County of Loudoun
Department of Planning
MEMORANDUM

SUBJECT: SPEX 2009-0004, SPEX 2009-0015 & CMPT 2009-0003
Scott Jenkins Memorial Park, 2nd Submission

SUBJECT: SPEX 2009-0004, SPEX 2009-0015 & CMPT 2009-0003
Scott Jenkins Memorial Park

Site Concept Plan

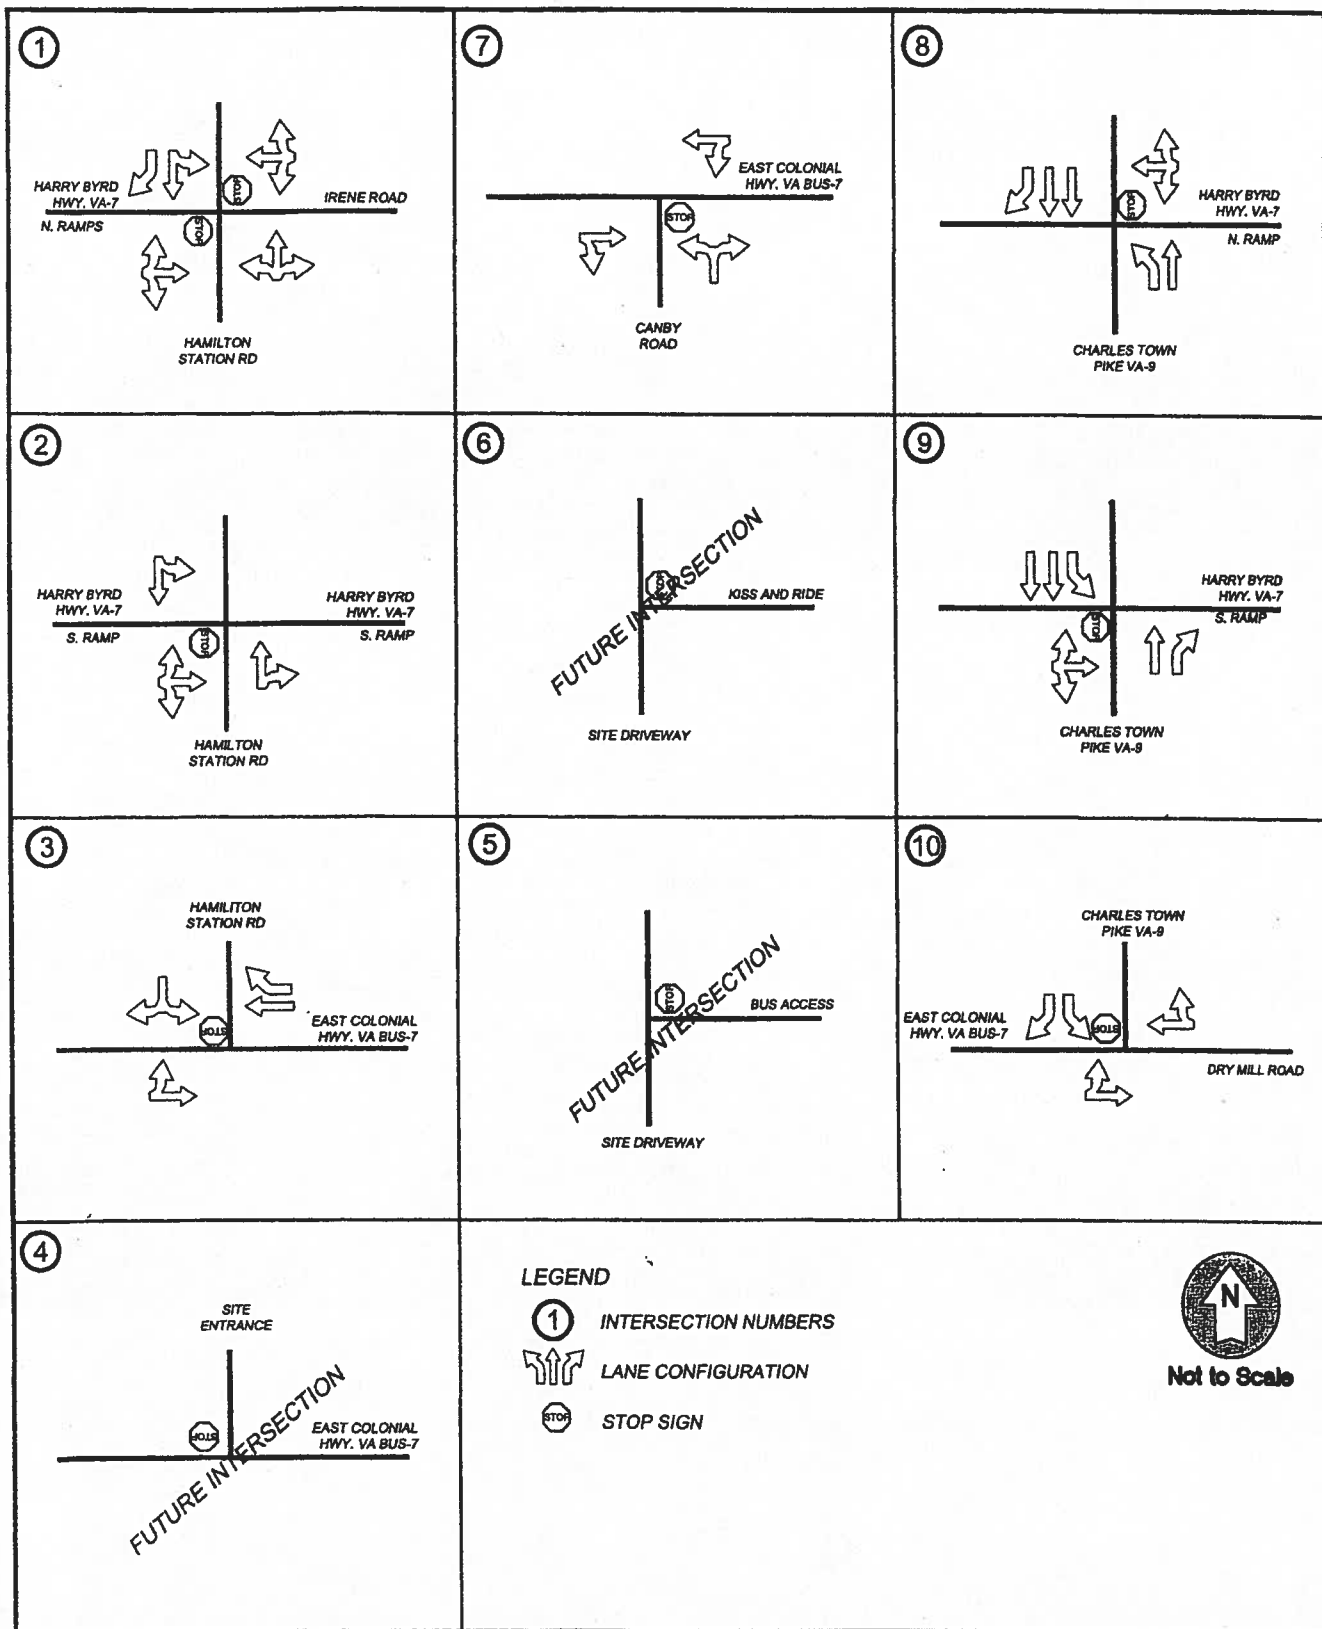
3. Initial Staff Comment (1st Referral): Consistent with the traffic study's 2010 recommendation, the eastbound left-turn lane into the main site entrance and the westbound right-turn lane into the bus access lane and main site entrance should be installed prior to the opening of Phase 1 of this project. In addition, the plat should be clarified to clearly indicate the length of each turn lane proposed.

4. Initial Staff Comment (1st Referral): It does not appear that the right-turn lane is long enough to allow for sufficient deceleration of buses accessing the site. The right-turn lane should begin at an appropriate point prior to the bus entrance.

Applicant's Response (August 11, 2009): The plat has been updated to include the turn lane lengths (taper + storage).

Applicant's Response (August 11, 2009): The right turn length into the bus area has a storage length of 410 feet to the return and 190 foot taper. The VDOT Road Design Manual requirements show a 200 foot turn lane with 200 foot taper. The increase in storage length, as measured from the bus entrance curb return, reflects adequate AASHTO deceleration area for the buses at a 55 MPH speed, with the inclusion of turn lane and taper area. The proposed design should satisfy VDOT requirements.

Total (2010) Left Turn Warrant @ E Colonial Hwy/Site Driveway

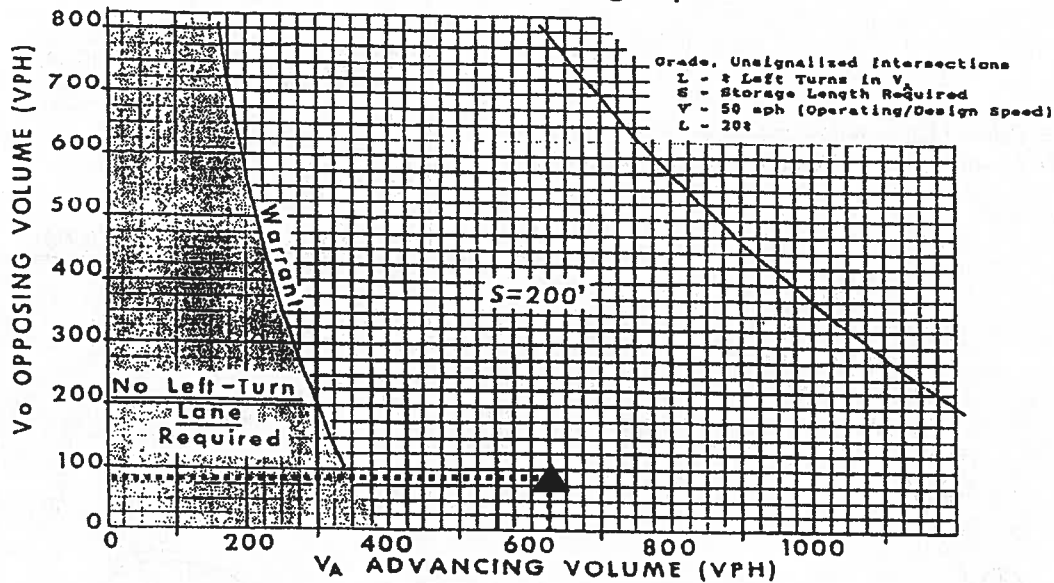
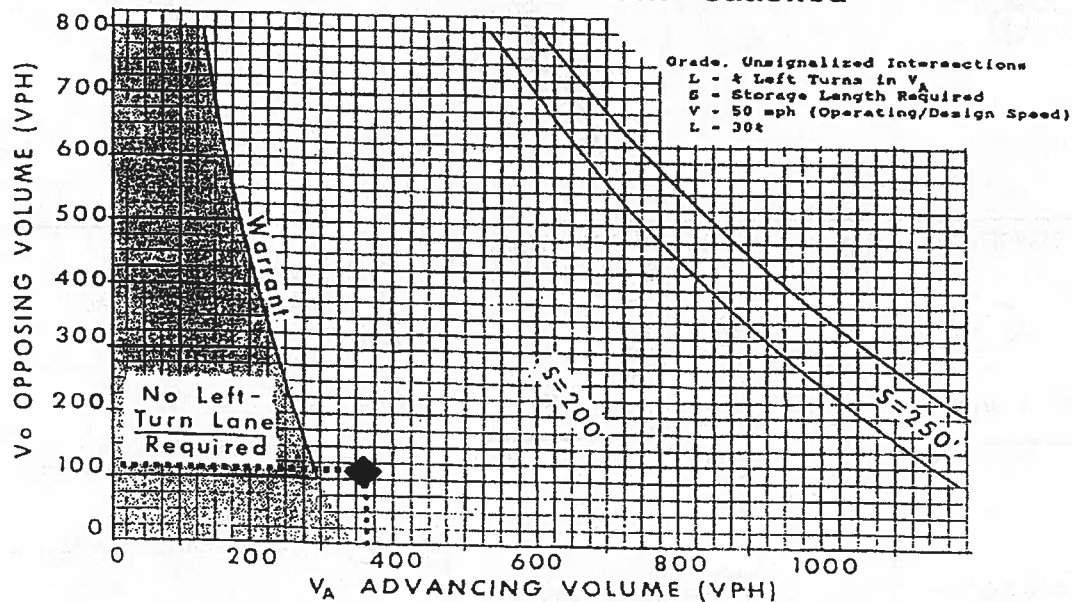
2. Initial Staff Comment (1st Referral): OTS staff requests further explanation of the "alternative length" measurement used in the traffic study [Attachment 16 in the 1st OTS referral]. In addition, OTS would like to know why the westbound left-turn lane length provided at the main site entrance (510 feet) is shorter than the maximum length (550 feet) noted in the study [Attachment 16 in the 1st OTS referral].

Applicant's Response (August 11, 2009): The table was derived by PHR+A from VDOT Location and Design calculations for another public road project in the County. The Alternative AASHTO column was shown to reflect the VDOT L&D, Traffic Engineering, and Land Development direction that the AASHTO turn lane standards could be satisfied based on the length of turn lane and storage. No written standards have been adopted by VDOT other than revisions to the VDOT Regional Road Design Manual. However, based on current land use application review regarding design waivers, since Business 7 is not a National Highway System Route, the application of the VDOT Road Design Manual minimum turn lane standards should apply. Or a 55 MPH speed limit, the turn lane storage is based on capacity analyses for urban conditions with a minimum storage length of 200 feet. A 200 foot taper is required for roads with over 45 MPH design speed. For the subject site use, PHR+A revised table 10, as attached, to show the storage requirements in relation to VDOT Road Design standards and concluded that the turn lane[s] are adequate. The comparisons also show the minimum turn lane requirements for AASHTO guidelines for 50 [MPH] and 55 [MPH] design speeds, for comparison purposes. The left turn lane into the site is 510 feet (410 ft turn plus 100 ft taper) allows for storage and deceleration per AASHTO minimum requirements at 50 MPH design, and exceeds the minimum VDOT standards of 400 feet. VDOT review did not highlight any turn lane issues.
